CITY PLAN COMMISSION**THURSDAY, MARCH 07, 2024****FILE NUMBER:** S212-183R**SENIOR PLANNER:** Hema Sharma**LOCATION:** Fisher Road, at the terminus of Patrick Drive**DATE FILED:** February 08, 2024**ZONING:** R-7.5(A)**CITY COUNCIL DISTRICT:** 9**SIZE OF REQUEST:** 1.349-acre**APPLICANT/OWNER:** LeComte Group, LLC

REQUEST: An application to replat a 1.349-acre tract of land containing all of Lots 1 through 3, and a tract of land in City Block 2962 to create 6 residential lots ranging in size from 7,515 square feet to 11,536 square feet and to remove an existing 30-foot platted building line along the north line of Fisher Road on property located on Fisher Road, at the terminus of Patrick Drive.

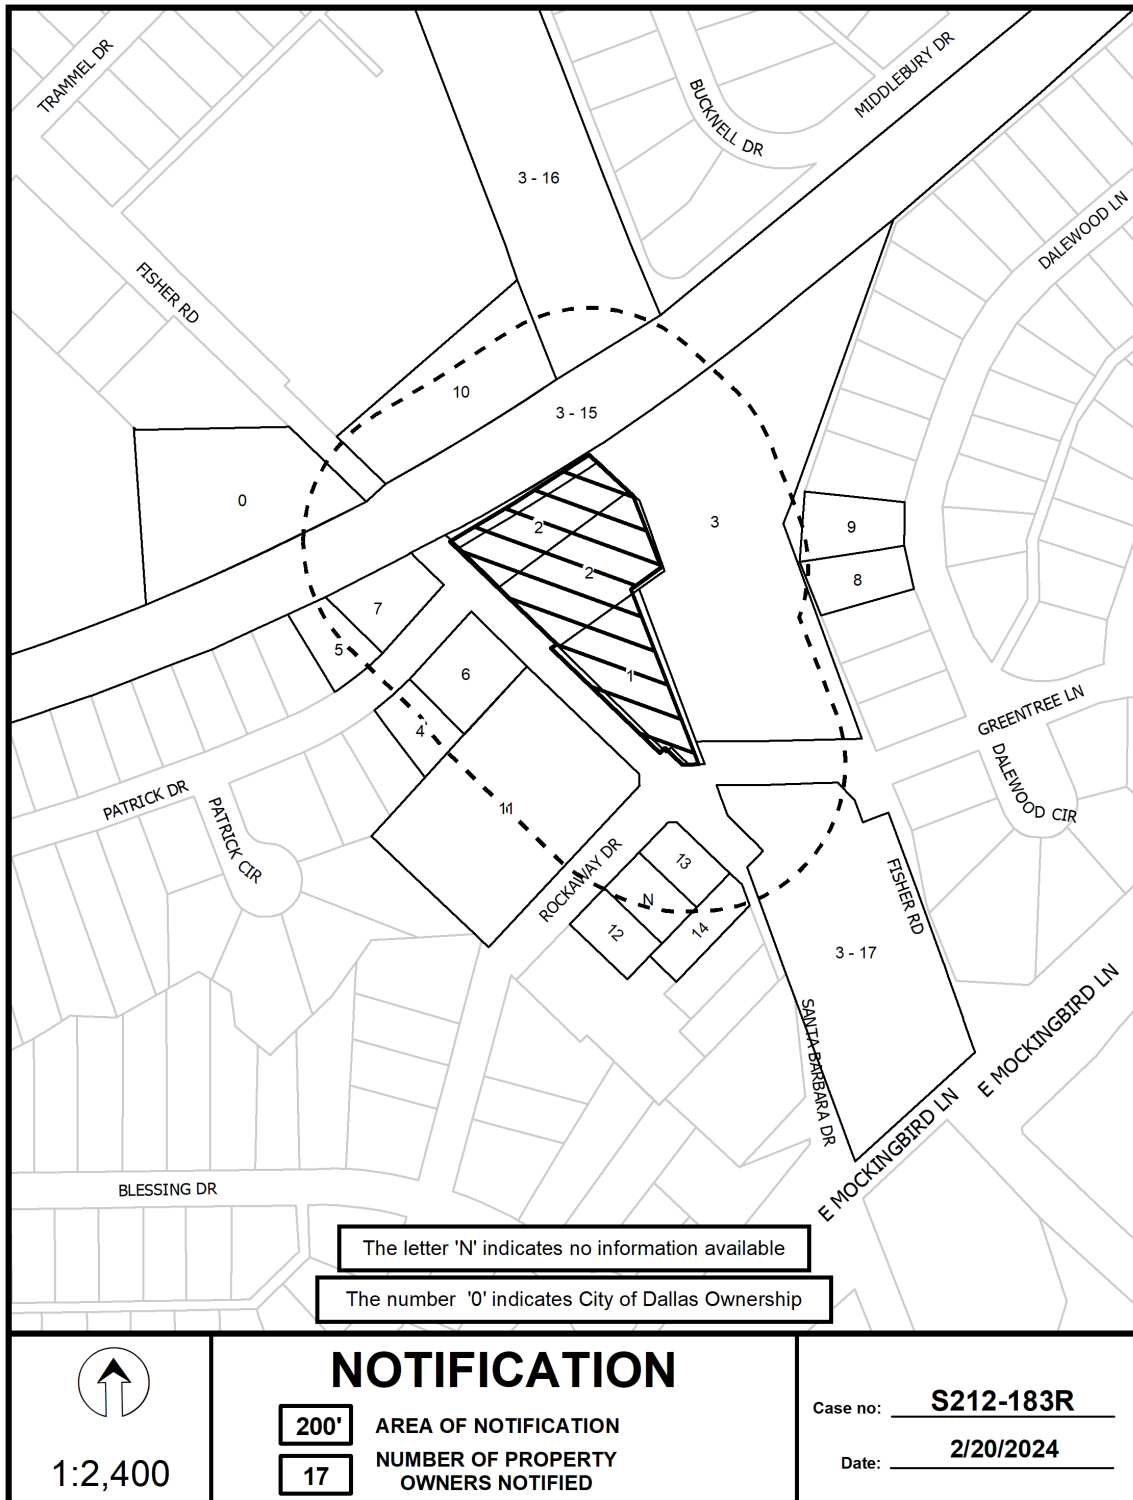
26. Prior to the final plat, please confirm that the well shown on plat in the Fisher Road right-of-way. If so, please confirm the well is plugged.
27. On the final plat, identify the property as Lots 1 through 6 in City Block A/2962.
